REMARKS

Reconsideration of the above-identified patent application, as amended, is respectfully requested.

Amendments to the Drawings

FIG. 1

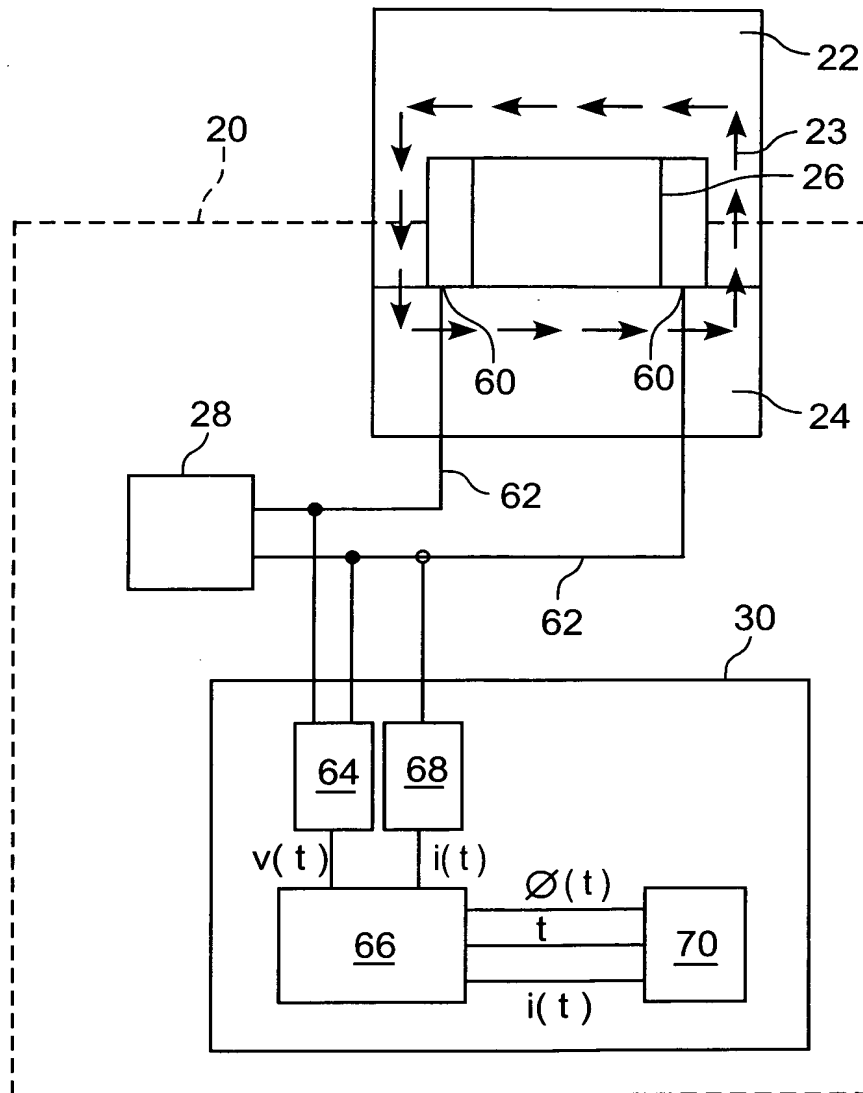
The drawings are objected to because 1) items (22) and (24) appear to point to the same thing in FIG. 1, 2) the difference between (22) and (24) in Fig. 2 is not clear, and 3) item (60) in FIGS. 2-5 is not mentioned in the specification. The drawings are also objected to under 37 CFR § 1.83(a) because they do not show “the flux coil leads coupling the flux coil to the monitoring device” as recited in claim 17.

Regarding item 1), applicants have attached hereto an annotated sheet showing changes (in red) made to FIG. 1. In FIG. 1, a horizontal line has been added through the item labeled (22) and (24) to distinguish item (22) (the magnetic component) from item (24) (the flux path closure device). This horizontal line is positioned relative to items (22) and (24) in a manner that is consistent with existing FIGS. 2-5. No new matter has been added by this change to FIG. 1. Applicants have also attached hereto a replacement sheet that replaces original drawing page 1 showing FIG. 1.

1. A replacement sheet for FIG. 1. This sheet replaces original page 1 of 10 of applicants' drawings.
2. An annotated sheet showing changes made to FIG. 1 in red. In the replacement and annotated sheets for FIG. 1, a horizontal line was added, consistent with FIGS. 2-5, to clearly separate components (22) and (24).
3. A replacement sheet for FIG. 2. This sheet replaces original page 2 of 10 of applicants' drawings.
4. An annotated sheet showing changes made to FIG. 2 in red. In the replacement and annotated sheets for FIG. 2, the original reference number (24) and its associated connecting line have been deleted, and the reference number (20) located just above "FIG. 2" has been changed to (24). This resulting designation of items (22) and (24) is consistent with FIGS. 3-5.

FIG. 2

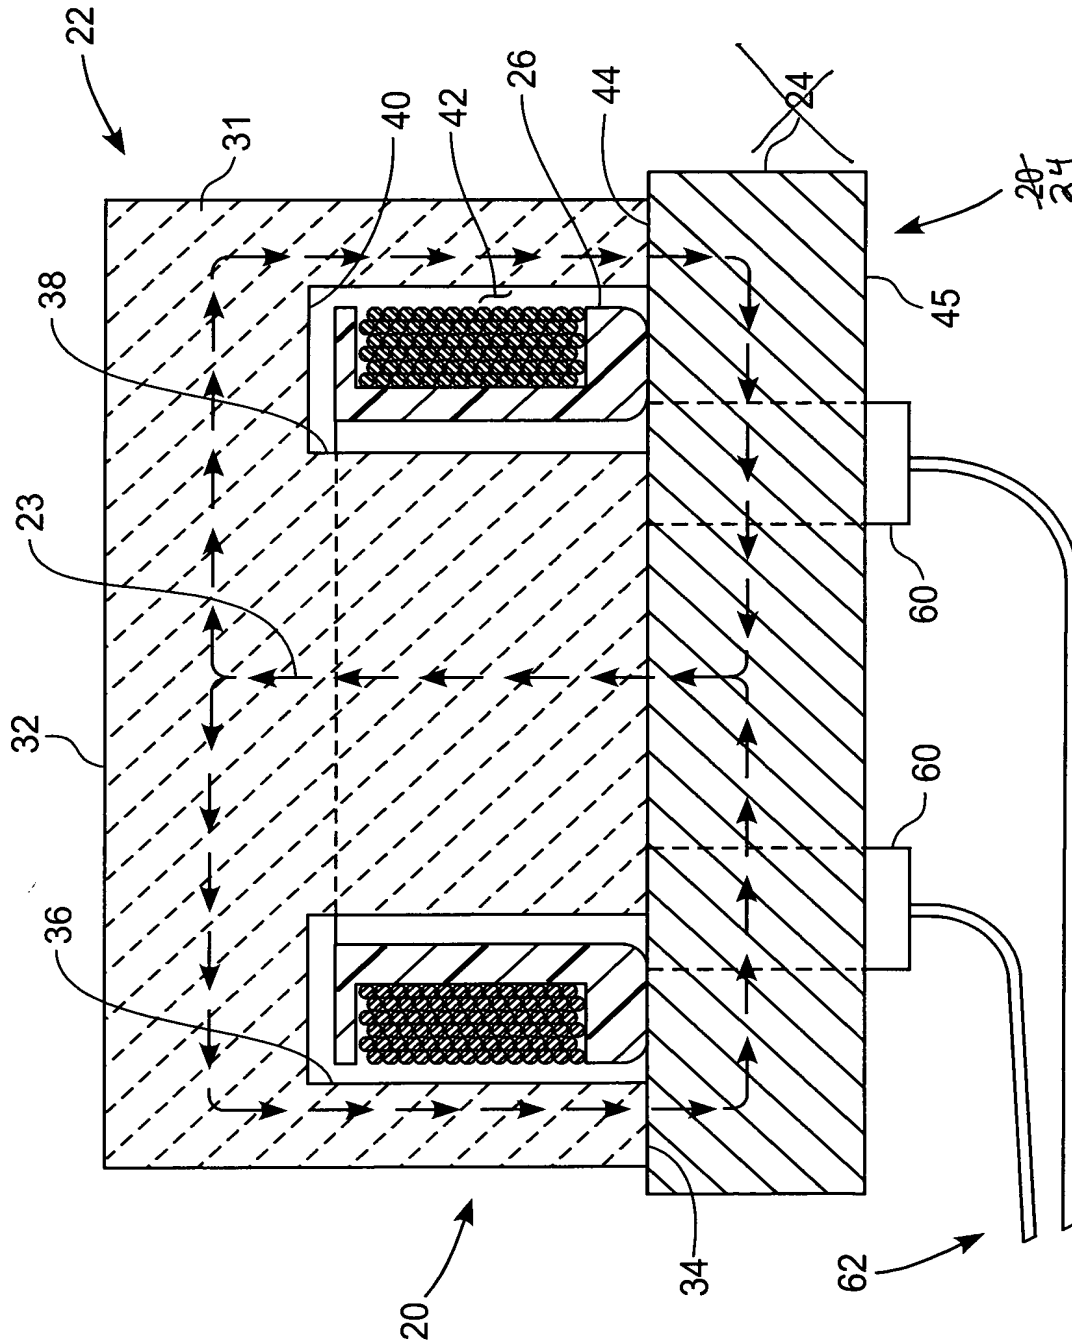
Regarding item 2), applicants have attached hereto an annotated sheet showing changes (in red) made to FIG. 2. In FIG. 2, the reference character (24) and its associated connecting line have been deleted, and the reference character (20) located just above “FIG. 2” has been changed to (24). This designation is consistent with applicants’ FIGS. 3-5, and identifies that the component with the dashed-line cross hatching is component (22) (the magnetic component) and that the component with the solid-line cross hatching is component (24) (the flux path closure device). No new

matter has been added by these changes to FIG. 2. Applicants have also attached hereto a replacement sheet that replaces original drawing page 2 showing FIG. 2.
